NEEDHAM PLANNING BOARD Tuesday, November 7, 2023 7:00 p.m.

- 7:00 p.m. Major Project Site Plan Special Permit No. 2023-03: Neehigh LLC, 93 Union Street, Suite 315, Newton Center, Petitioner. (Property located at 629-661 Highland Avenue, Needham, Massachusetts). Regarding request to demolish the five existing buildings on the property and build a single two-story 50,000 square feet Medical Office Building (25,000 square feet footprint) with two levels of parking (one at-grade and one below grade) totaling two hundred and fifty (250) spaces. Please note: This hearing has been continued from the September 5, 2023 and October 17, 2023 Planning Board meetings.

The applicant intends to demolish the five existing buildings on the property and build a single two-story 50,000 s.f. Medical Office Building (25,000 s.f. footprint) with two levels of parking (one at-grade and one below grade) totaling two hundred and fifty (250) spaces. The two stories of the building itself are located directly above a parking area that is partially above grade and thus for zoning purposes counts as an additional story; and a three-story building is allowed in this zoning district. The proposed project will

93 Union St, Suite 135 Newton Centre, MA 02459 Project #: 14781.00 **Scale:** 1" = 20' Issue: PLANNING BOARD **Revisions:** PB REVIEW COMMENTS

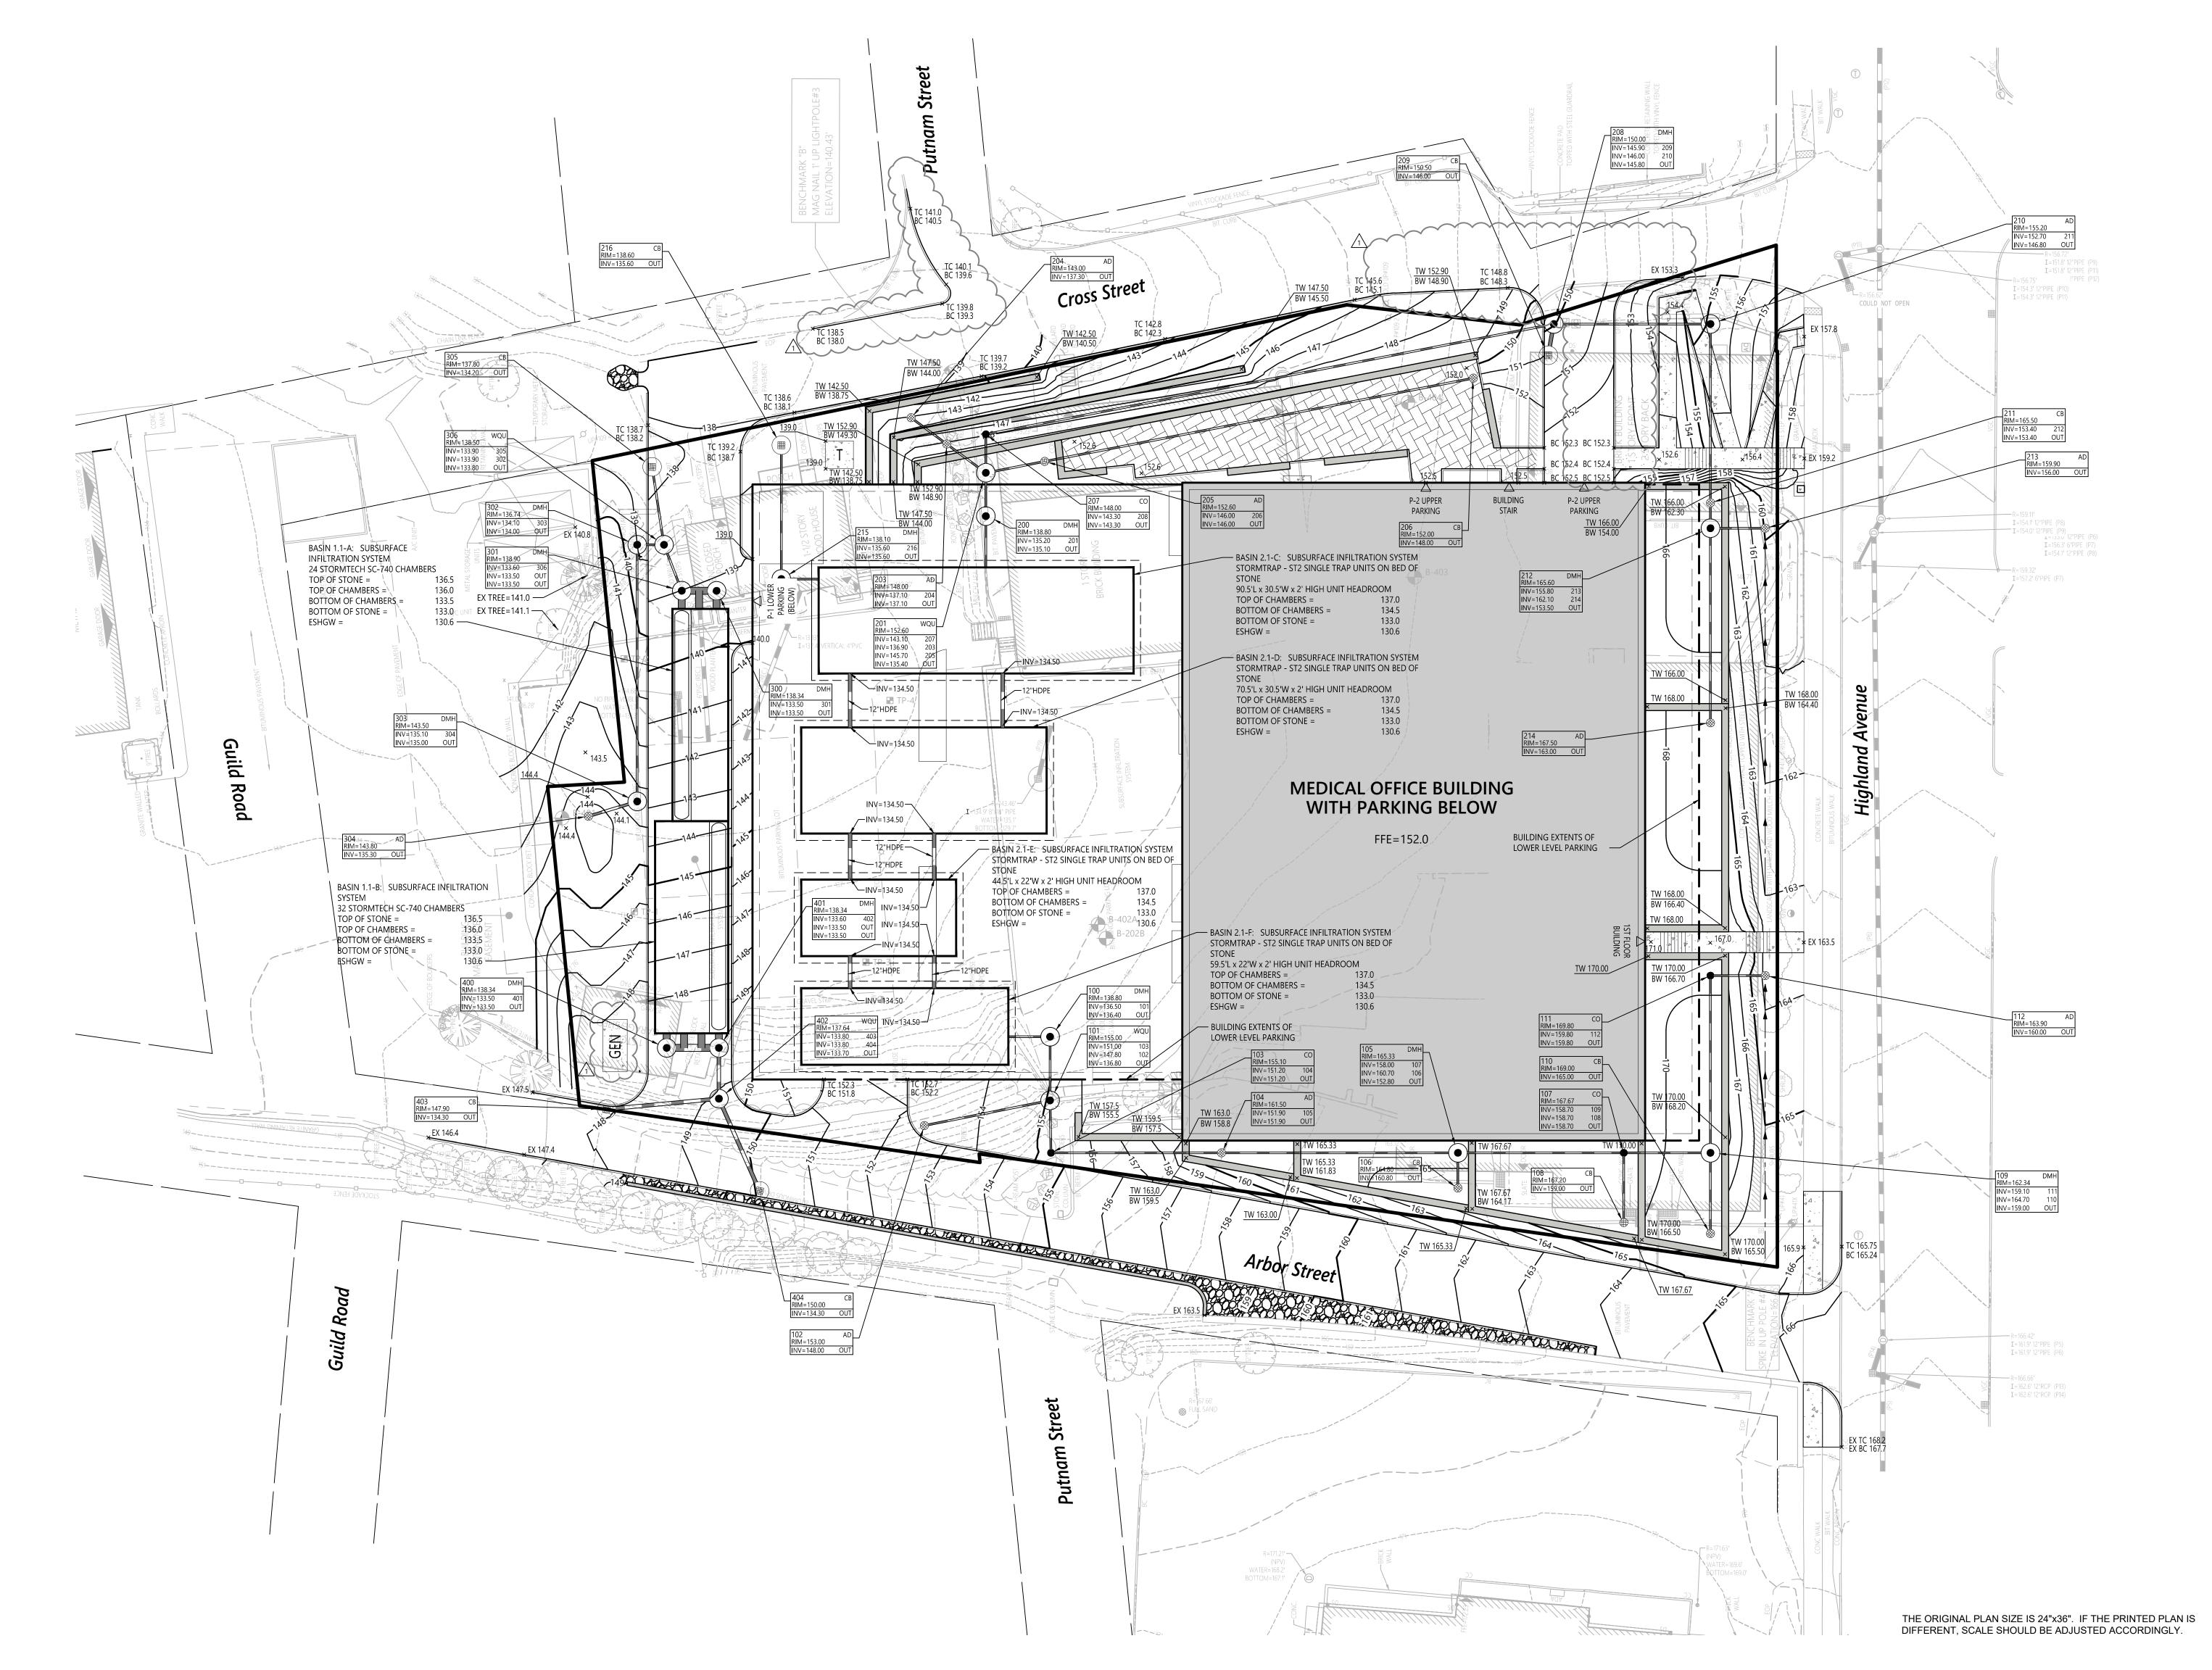
40. Sheet C3.01 depicts a pedestrian crosswalk across Arbor Street at the Highland Avenue intersection. This approach should also include a bike crosswalk and ramp to accommodate the sidewalk level bike lane.

Please see the attached PDFs for the revised civil site plans (C1.01, C3.01, C4.01, C5.01), truck turning (deliveries and garbage) and architectural upper parking level plan. These plans collectively depict the following changes per traffic and board comments:
